Planning Commission Staff Report

Project Type:	Ordinance Amendment
Meeting Date:	November 9, 2020
From:	Chris Dietz, Planner
Location:	15310 Conway Road
Description:	<u>P.Z. 06-2020 15310 Conway Road (SMS Group)</u> : A request to repeal and replace Ordinance 2463 to establish a new “PC” Planned Commercial District to modify development criteria for a tract of land totaling 1.492 acres located at the southwest corner of the intersection of Chesterfield Parkway East and Conway Road (18S310557).

RE: Responses to Planning Commission Comments - 15310 Conway Rd

Figure 4: Updated Landscape Buffers

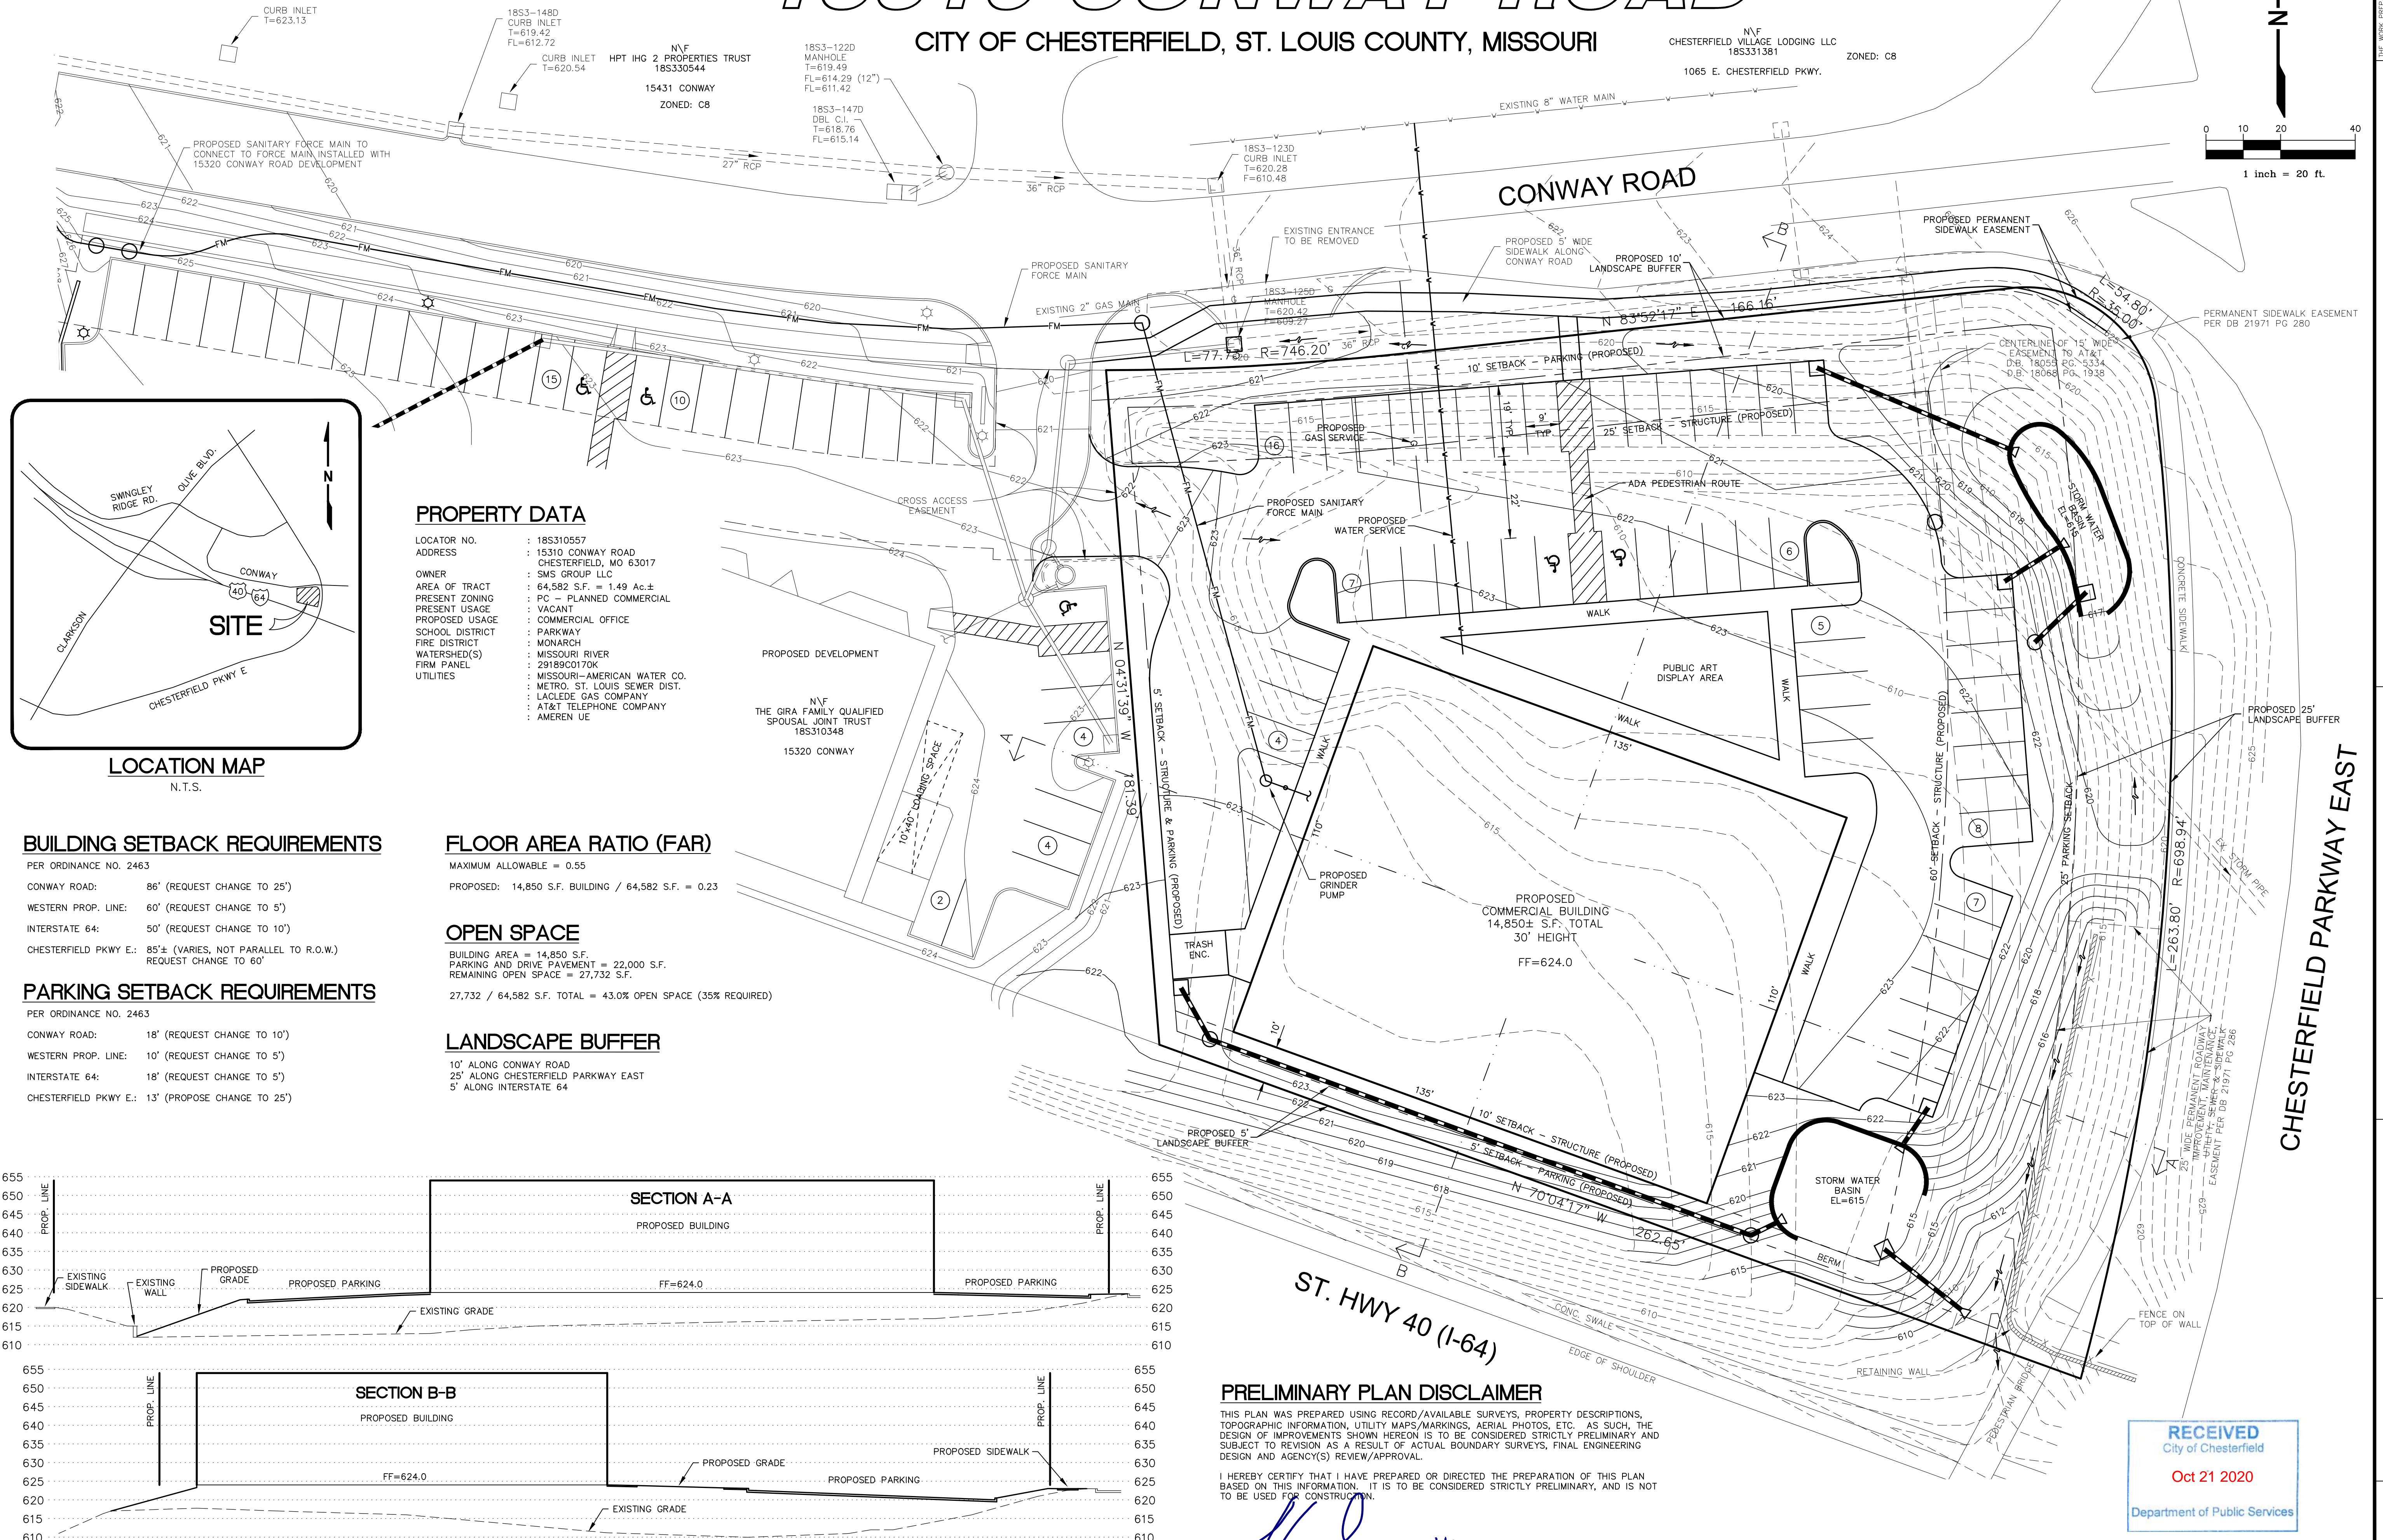
- **Issue:** Landscape Buffers—Because of the high visibility of the site from Chesterfield Parkway, Planning Commission noted that landscaping must be closely reviewed and expressed concern about the reduction of Landscape Buffers to match parking setbacks.

Response: By doubling the parking setbacks along Conway and Chesterfield Parkway, the applicant has increased the area of Landscape Buffer to the same depths of 10’ along Conway Rd. and 25’ along Chesterfield Parkway. Figure 4 shows the revised Landscape Buffers that align with parking setbacks in and around the subject site.

PRELIMINARY PLAN

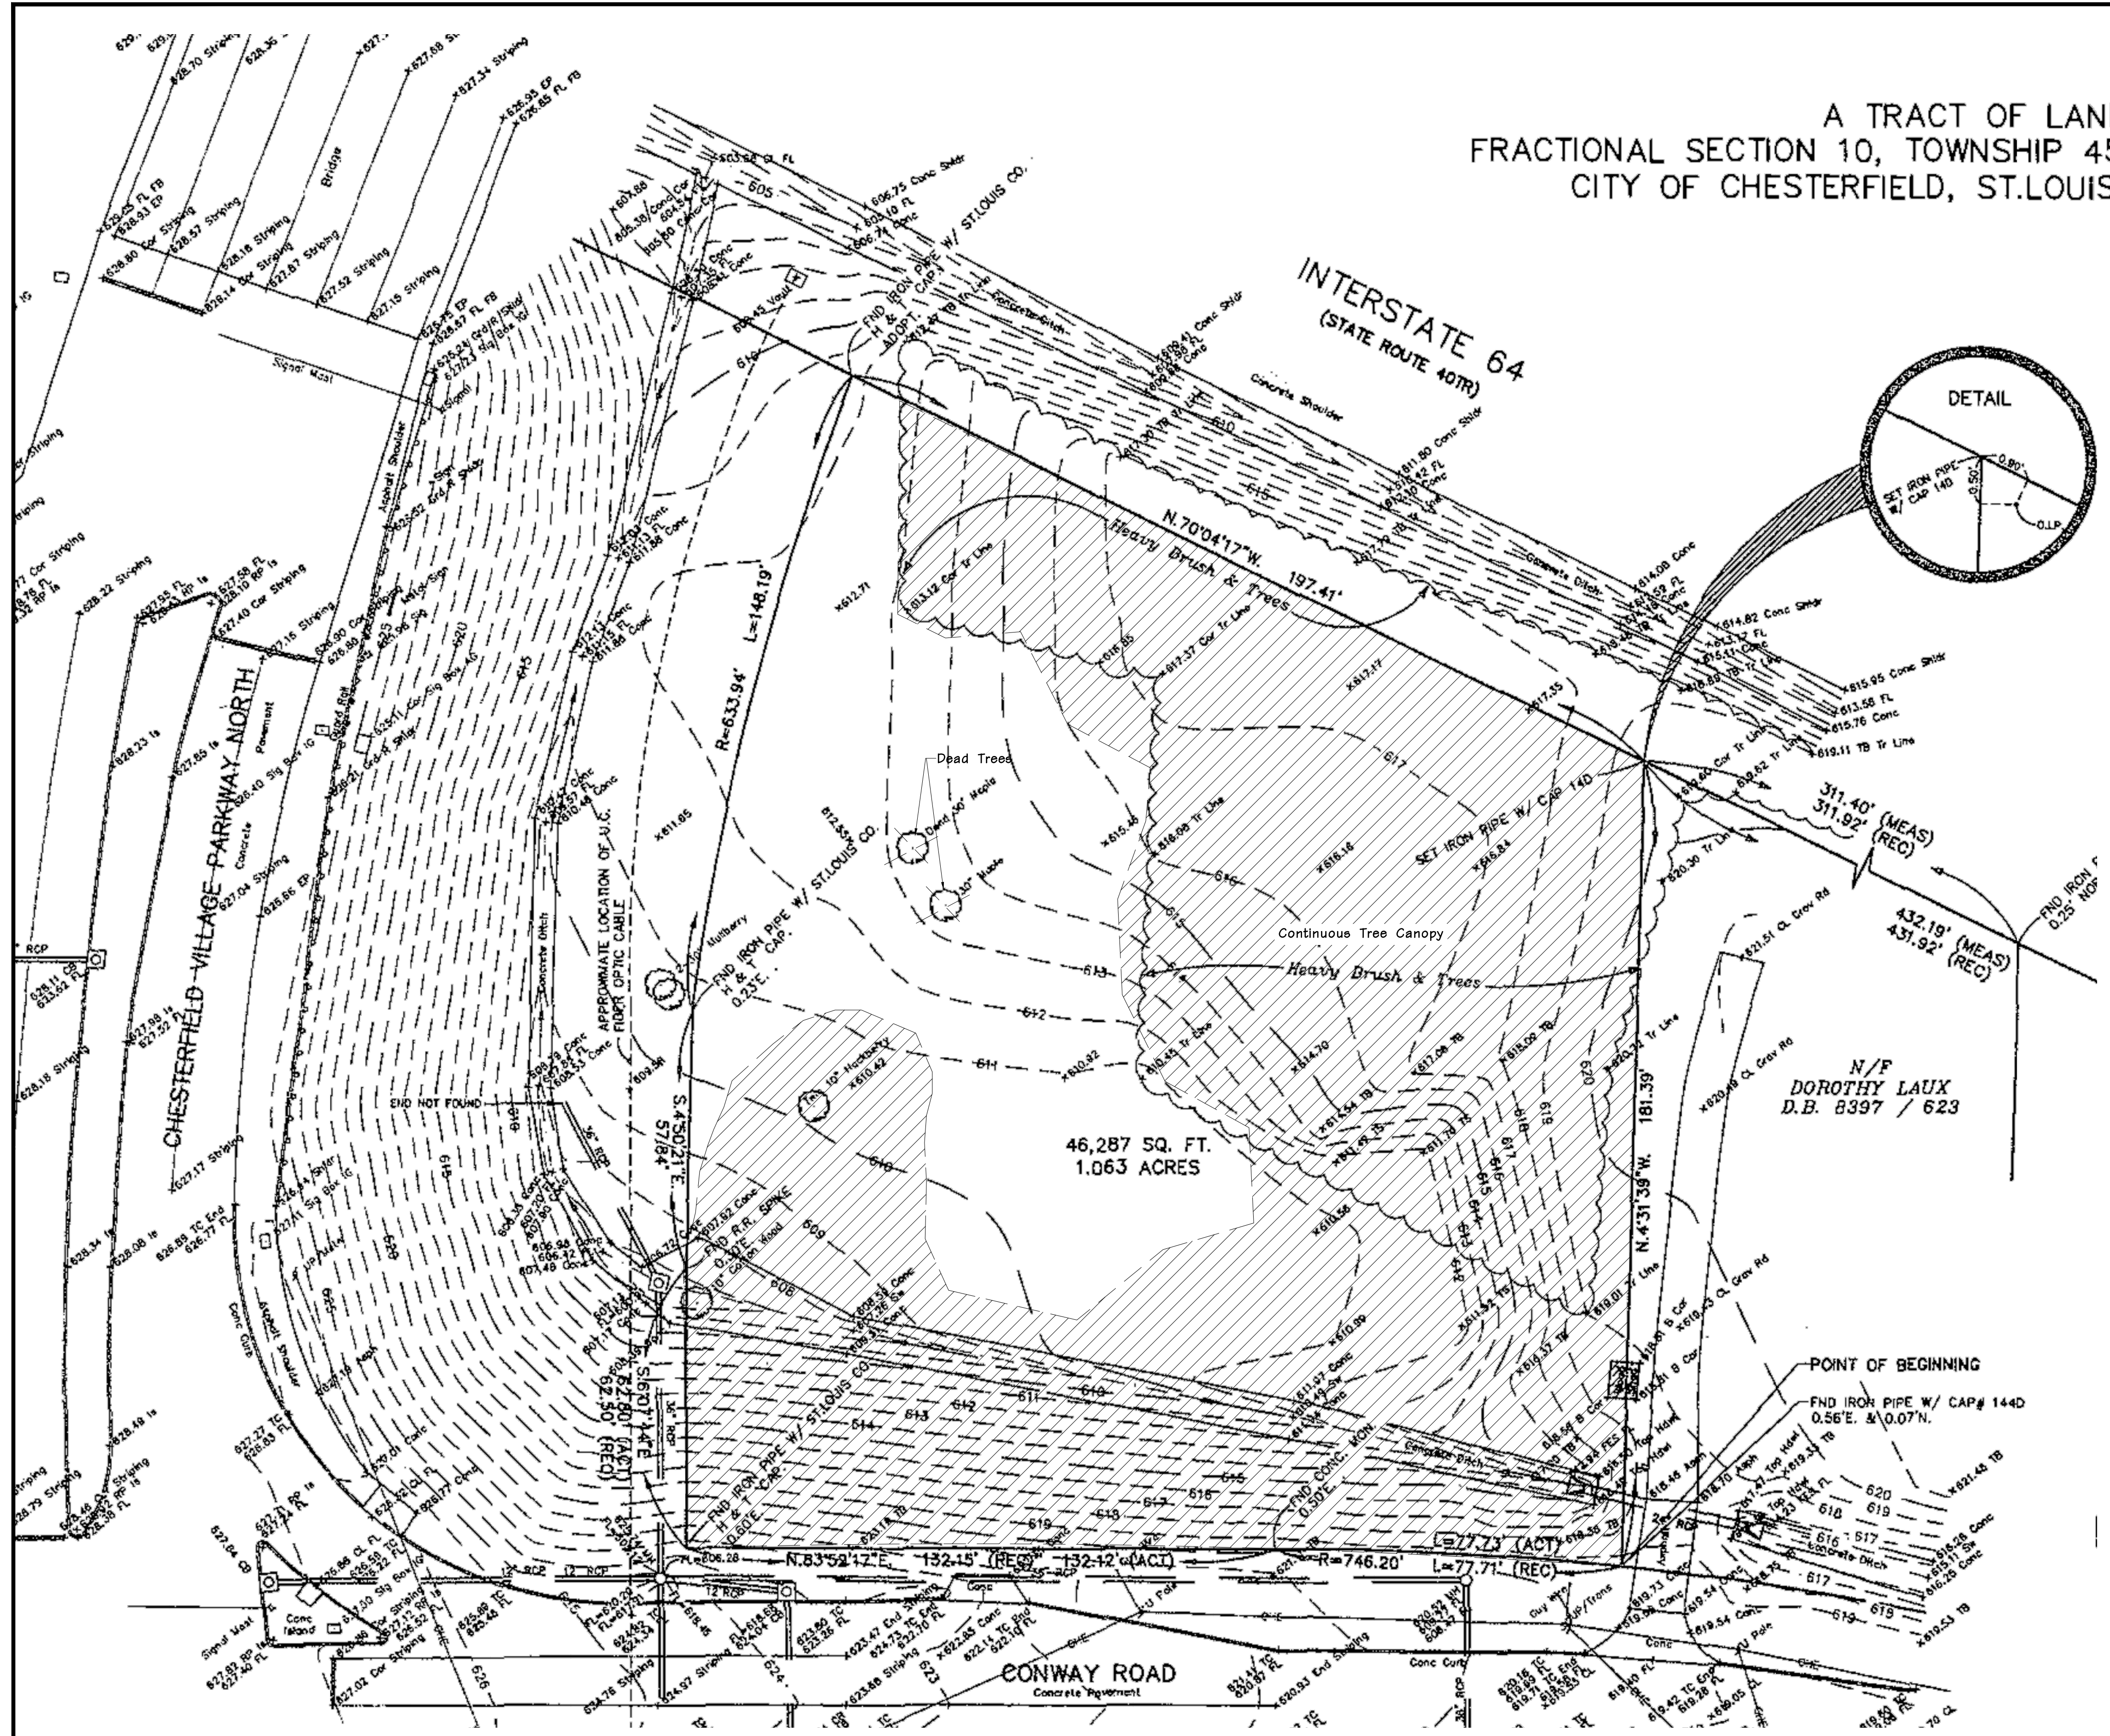
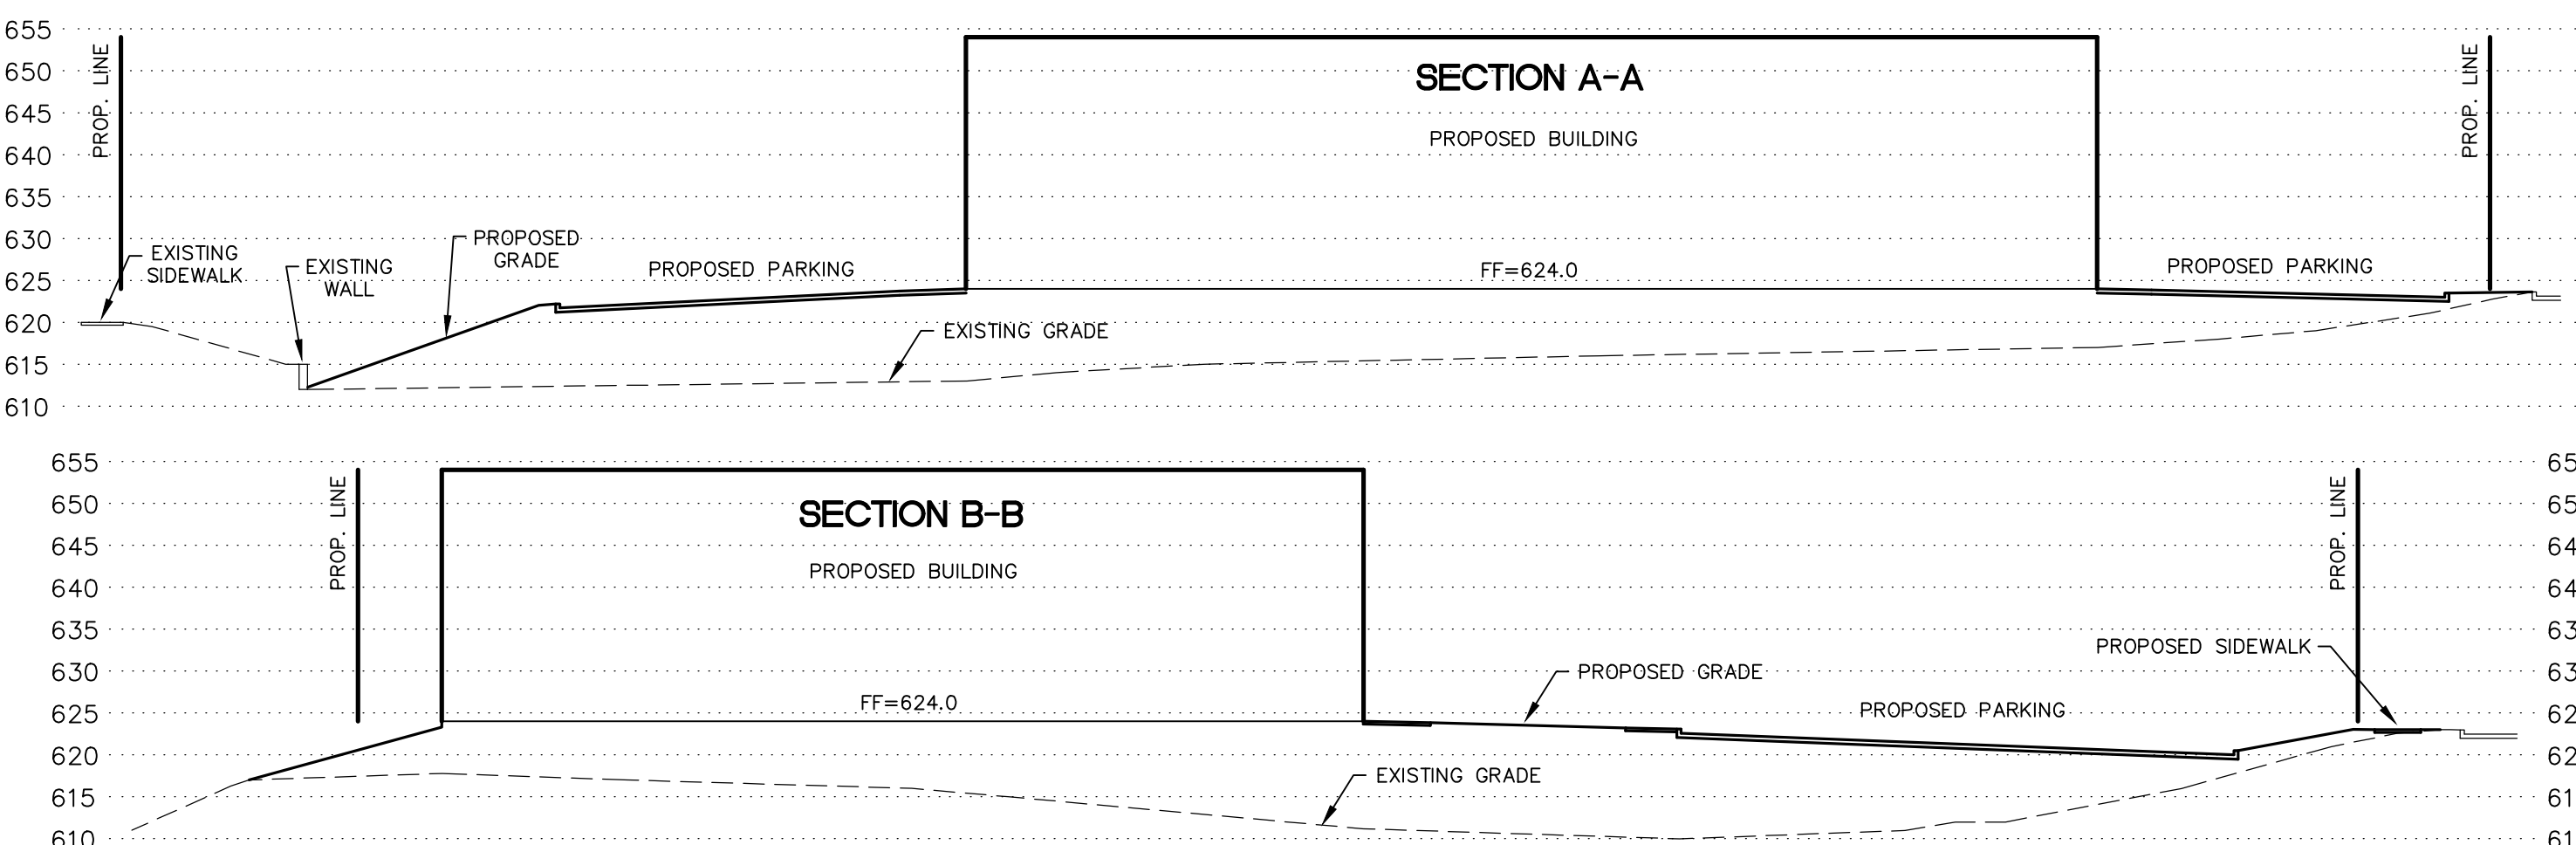
- **Issue:** Setbacks—Planning Commission expressed their concern that the proposed parking setbacks along Conway Road do not reflect those for the hotel development across the street.

Response: The applicant has made changes to the proposed setbacks relating to the northern and eastern boundaries along Conway Rd. and Chesterfield Parkway, respectively. The plan now reflects a northern boundary parking setback extended from five feet (5’) to ten feet (10’) to match that of the hotel development across the street. The eastern boundary parking setback has also been extended from the previous request of thirteen feet (13’) to twenty-five feet (25’). These figures are updated in the parking setback table below:

- a. We have made changes to our proposed setbacks relating to the northern (Conway RD) and eastern (Chesterfield Parkway) boundaries. We have revised our plan and request to reflect a Northern Boundary setback at 10' for both parking and landscape allowing a 5' greater buffer than that of 15320 Conway Rd (adjoining to the west). We also adjusted the Eastern Boundary parking and landscape setbacks from the current 13' to 25' allowing for a greater buffer along Chesterfield Parkway. This is reflected on the project narrative and current site plan.
